## Bethesda Mews, Site Plan, 820130030

Date of Report: 4/1/13

### Summary

*Tree #78 is heavily impacted by the proposed Camberley Road extension*

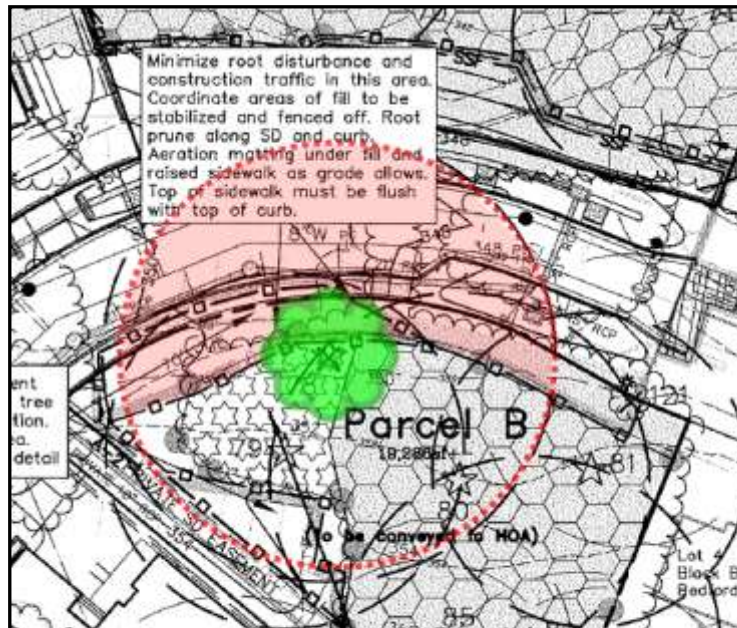
Tree #78 is the only additional *removal* requested under the revised variance request. The tree is located onsite immediately adjacent to the proposed ROW for the Camberley Avenue extension. (Refer to image below). The tree was previously granted a variance for impacts but not removal. Careful grading/sequencing and the use of root aeration matting had been proposed to retain the tree. The Applicant is currently requesting a variance for removal of the tree and has included replacement mitigation plantings. However the intention is to preserve the tree; further evaluation and possible field adjustments may result in its preservation.

As a result of the above findings, staff recommends the Board approve the Applicant's new request for a variance from Forest Conservation Law to impact (but retain) 16 subject trees and remove one subject
